**TITEL:** Inspektion av bultar till stjärtrotorväxellåda

**GÄLLER:** MD Helicopters Inc. modellerna 369D, 369E, 369F och 369FF  
modifierade enligt STC SH5055NM eller SH4801NM

**2002-13-05 MD Helicopters, Inc.: Amendment 39-12793. Docket No. 2001-SW-40-AD.**

**Figure 1 - Inspection Location**

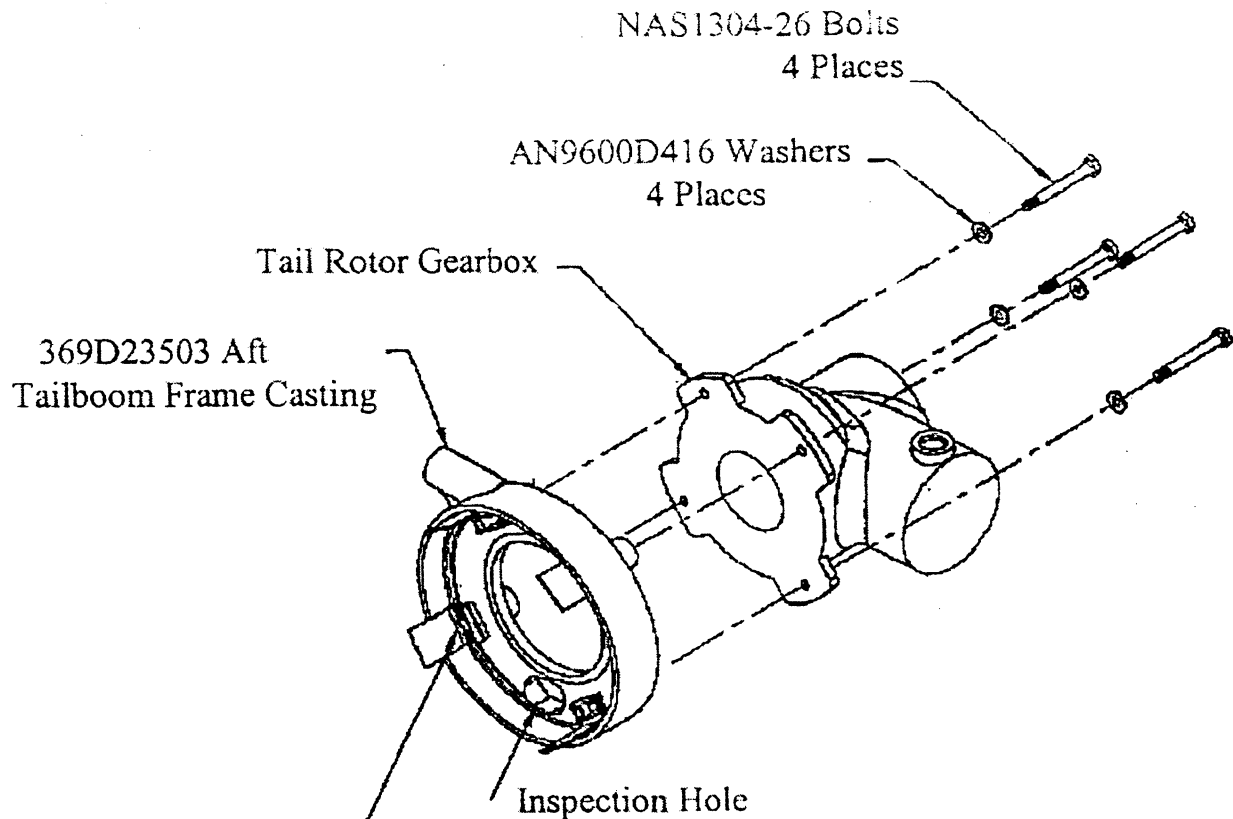
(2) Remove the tailboom control rod and determine the number of bolt threads protruding from each nutplate on the internal surface of the aft tailboom frame casting, P/N 369D23503, as shown in Figure 1 of this AD. At least one thread must protrude. If more than four threads protrude, add an additional washer, P/N AN960D416, under the bolt head. Torque the bolt to 100-110 in-lbs, and reapply a slippage mark. See Figure 1:

Inspect this area of each bolt.  
Bolt must protude at least one  
thread past end of nutplate  
4 places.

(ii) If the P/N cannot be determined or if the bolt is not P/N NAS1304-26, before further flight, replace the bolt with bolt, P/N NAS1304-26.

(iii) Torque the bolt to 100-110 in-lbs and apply a slippage mark.
